**CAPITOL ZONING DISTRICT COMMISSION**  
**STAFF REPORT**  
**4/26/17**  
**BIM**

**Location:** 1301 South Spring Street  
**Applicant:** J.B. Mullins for Matthew Mentgen  
**Permit Types:** Certificate of Appropriateness

**Project Description:** This application is for a Certificate of Appropriateness to allow for the construction of a new, two-story single-family dwelling, a detached two-car garage apartment, and related site improvements. The approximately 2,250 square foot “L-shaped” house will be covered with brick veneer, horizontal cement fiberboard lap-style siding and vertical standing-seam metal panels over a masonry foundation. The concrete porch is flanked by decorative masonry features and leads to a glass and metal front door. A balcony over the front porch features a similar door, along with a glass and metal balustrade. Windows will be fixed, metal-clad wood, in a variety of sizes, including floor-to-ceiling windows on a portion of the south façade. The shed roof is comprised of the same standing-seam metal panels that constitute much of the second-floor siding. The detached two-car garage to the rear includes a second dwelling unit above. This shed-roof outbuildi

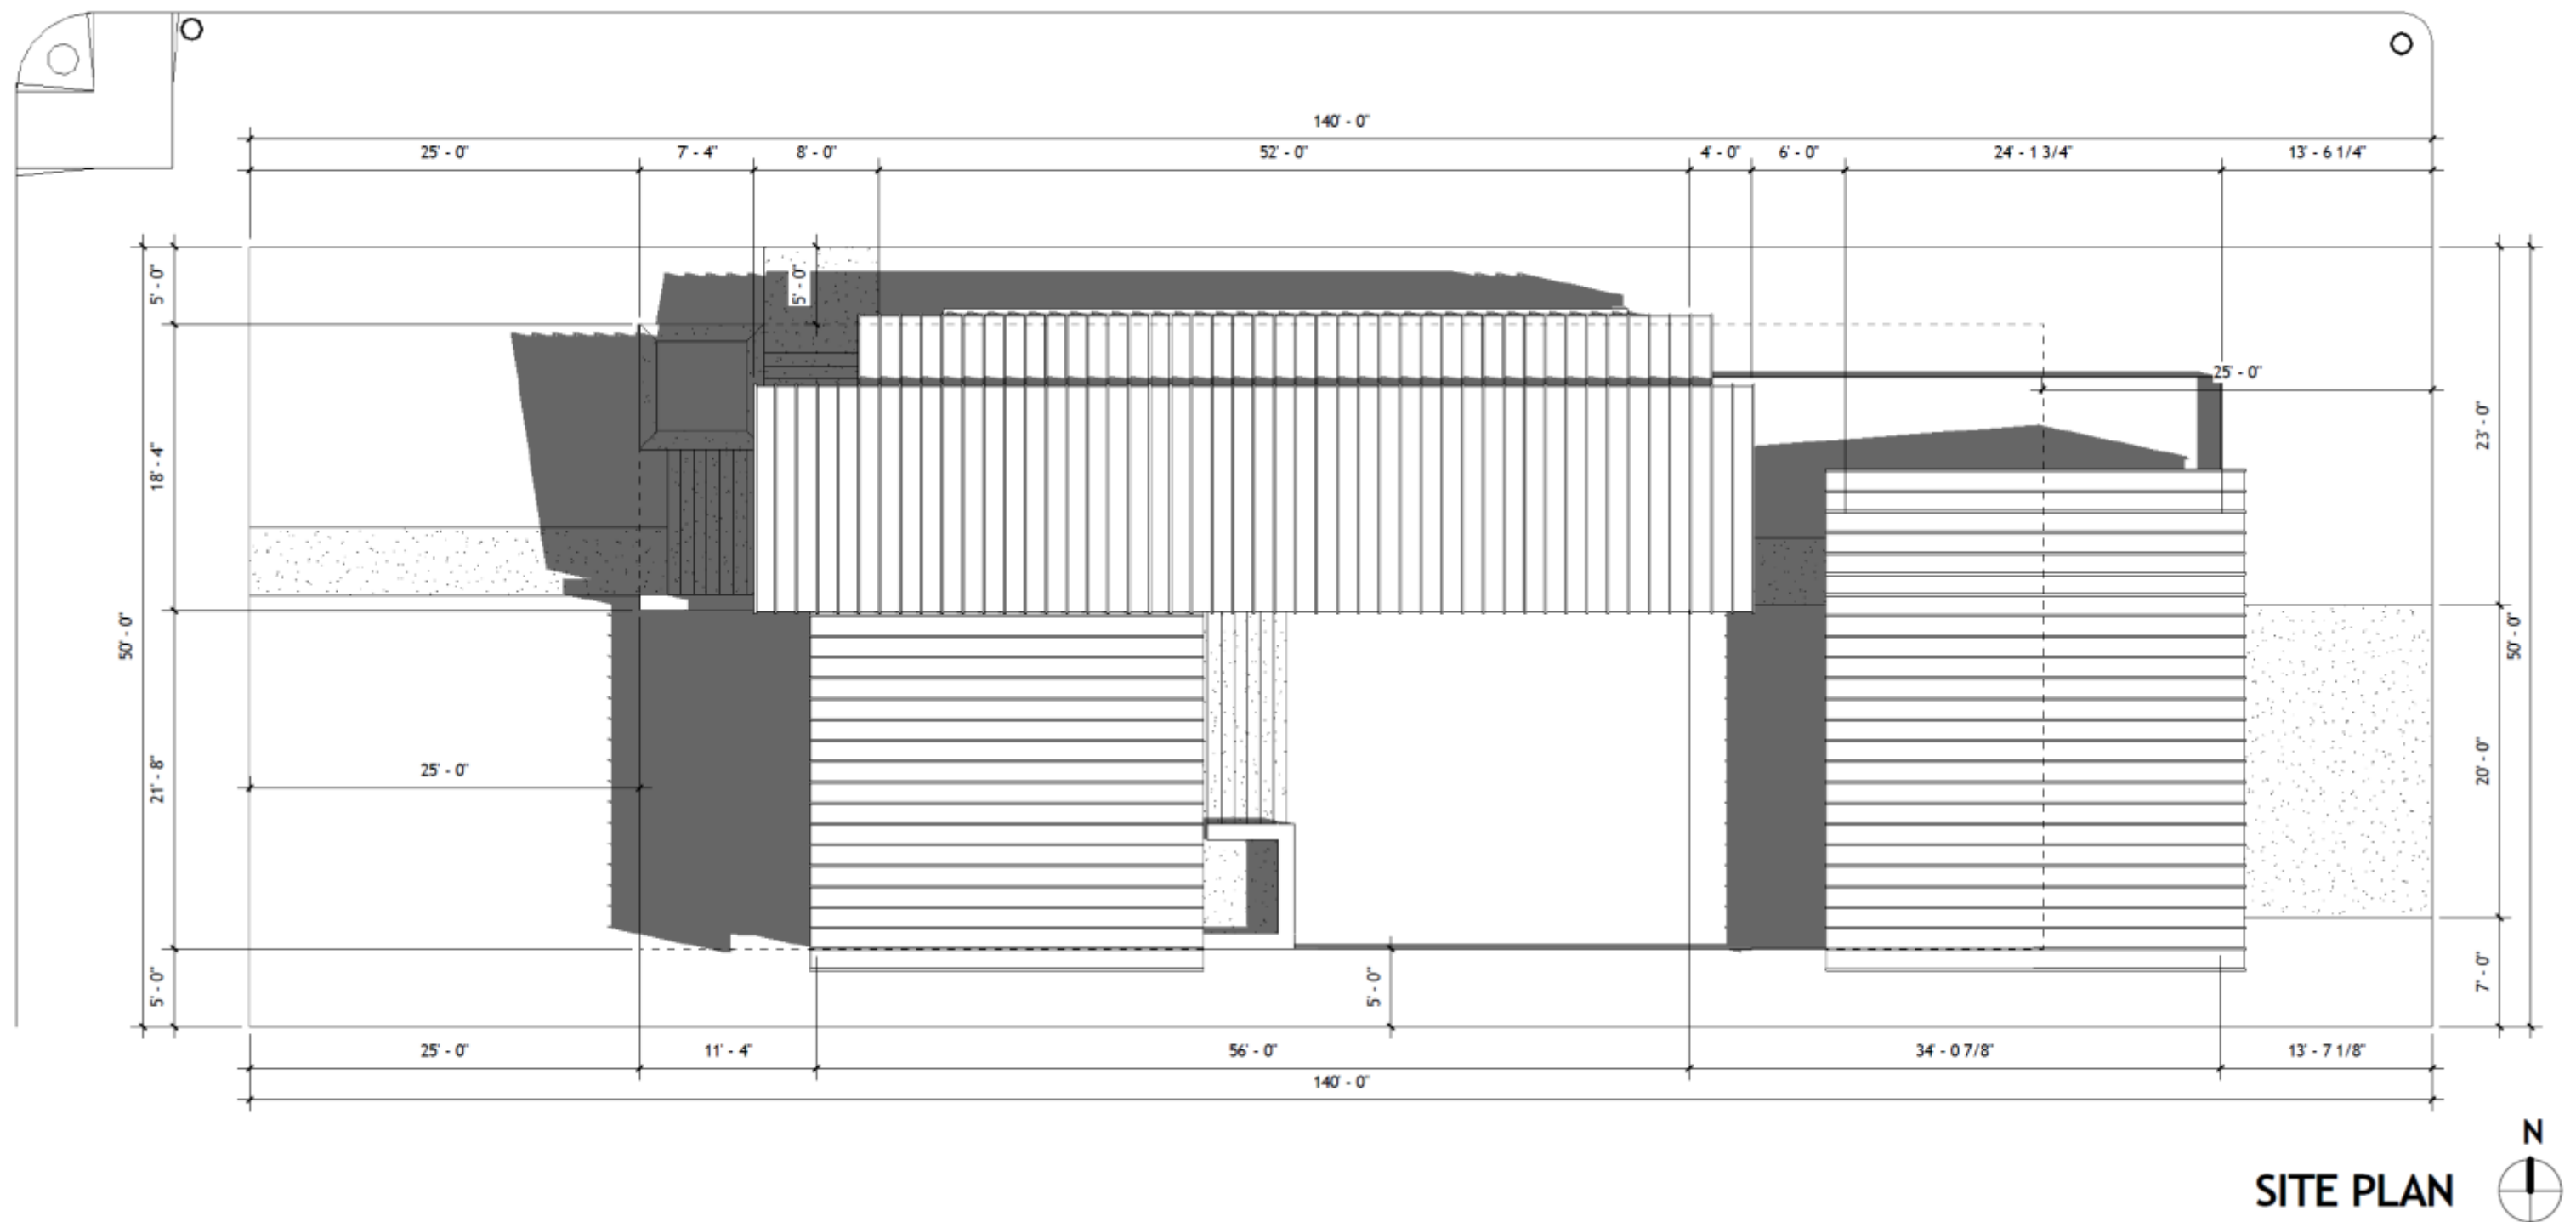
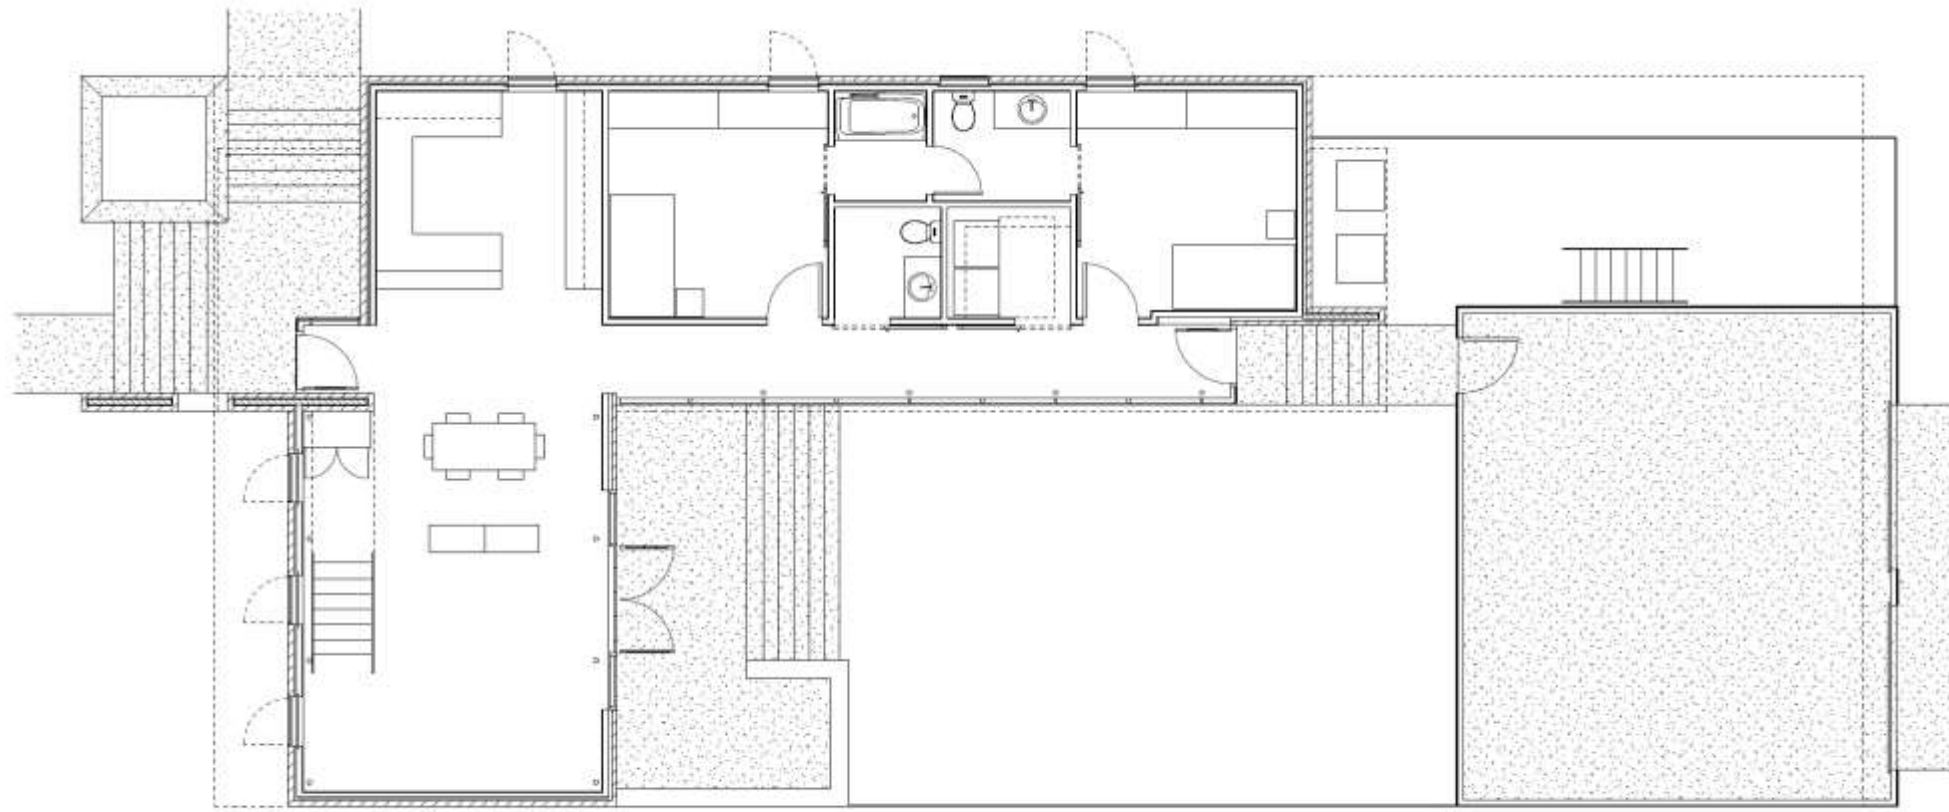
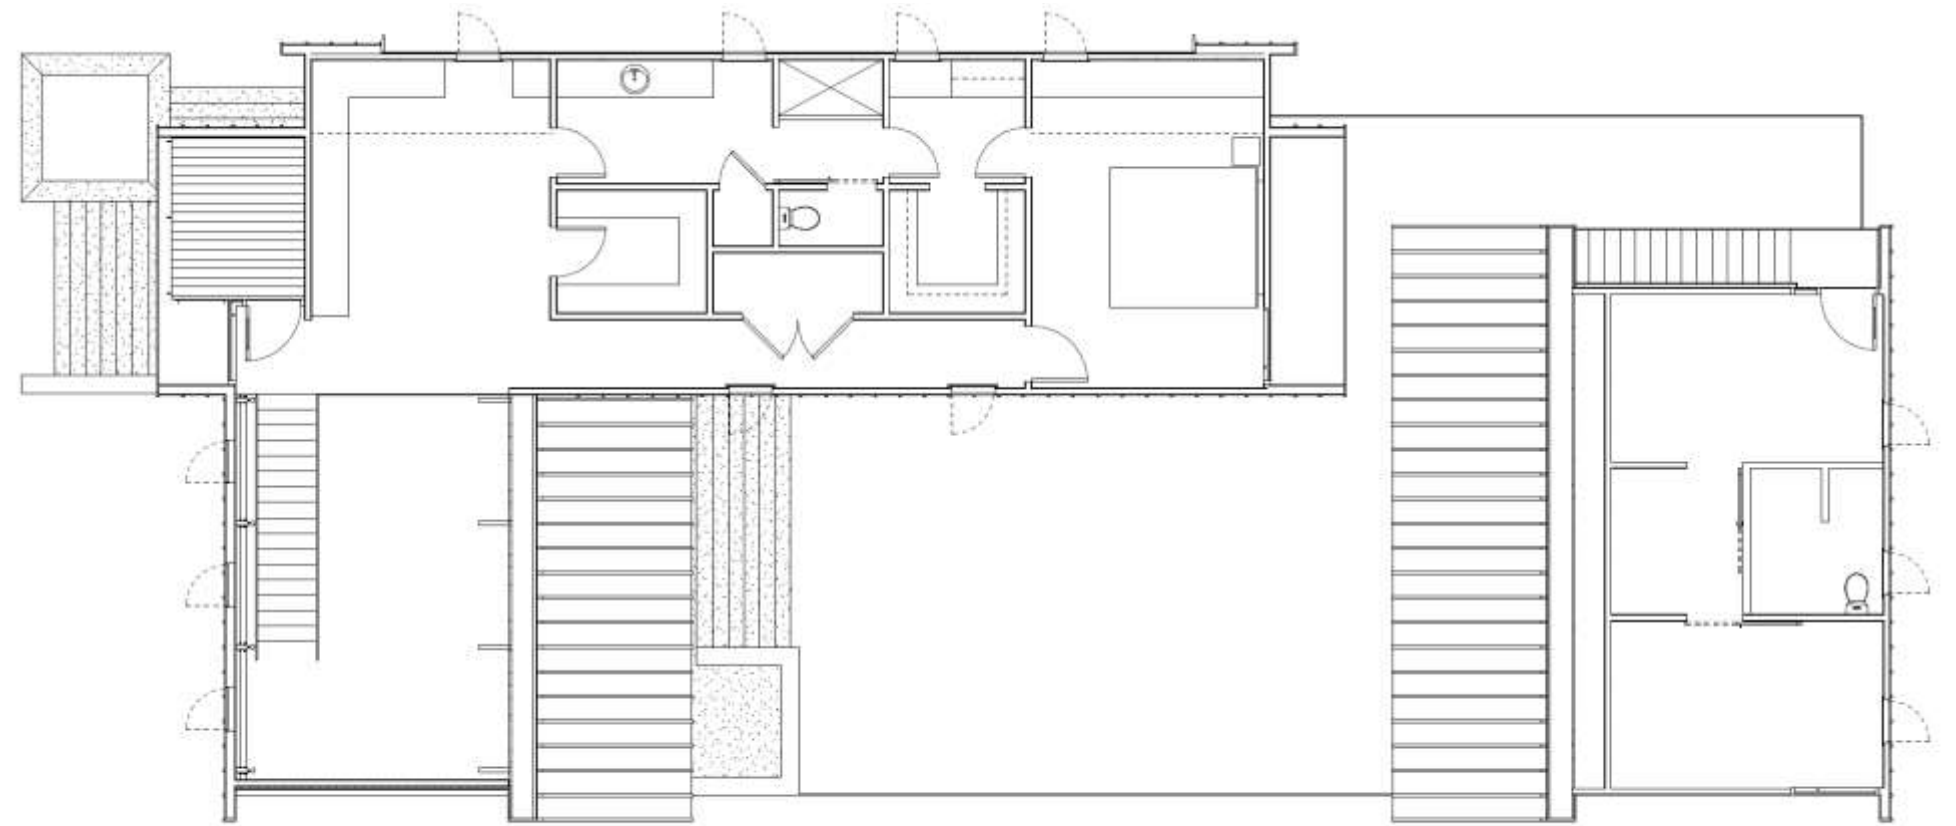
*Staff finds the proposal is partially consistent with this policy. Staff believes the proposed building's size and placement are generally compatible with the historic character of the neighborhood. Staff also believes, however, that the distinctly contemporary style of the house – the roof shape in particular – represents a substantial contrast with the existing context.*

*Staff finds the proposal is NOT consistent with these standards. The proposed shed roofs, trapezoid forms, and right triangles represent a substantial departure from the overall geometry of historic buildings in the area. (Staff notes, however, the roof's height and eave depths are similar to those seen traditionally.)*

Staff does not lightly recommend denial of an application for residential new construction, but regrettably, must arrive at that conclusion in this case. Staff commends the applicant's bold vision and willingness to invest in the District. Staff urges the applicant to consider more a more traditional building form, with a hipped and/or gabled roof, and a more vertical orientation.

### Alternate Design #1

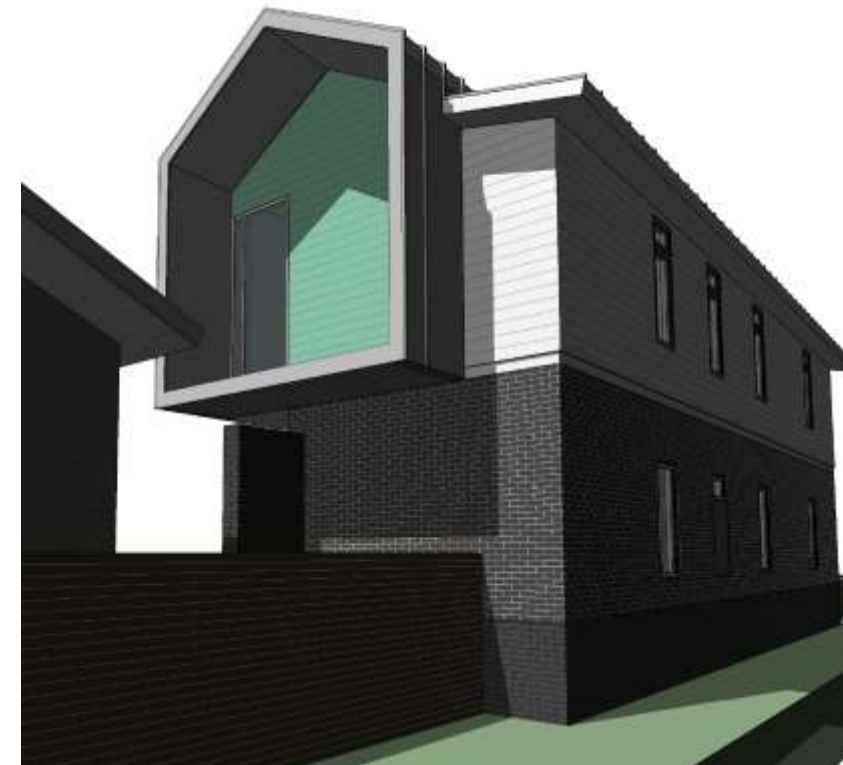
**Design Review Committee Recommendation:** A motion to recommend approval of alternate design #1 (see page 25) – with a special notation that this property is located at the edge of the Mansion Area, adjacent to other Modernist structures, and that approval should not be construct as precedent-setting – failed unanimously (0-6). One member recused from the vote citing a professional relationship with the applicant.
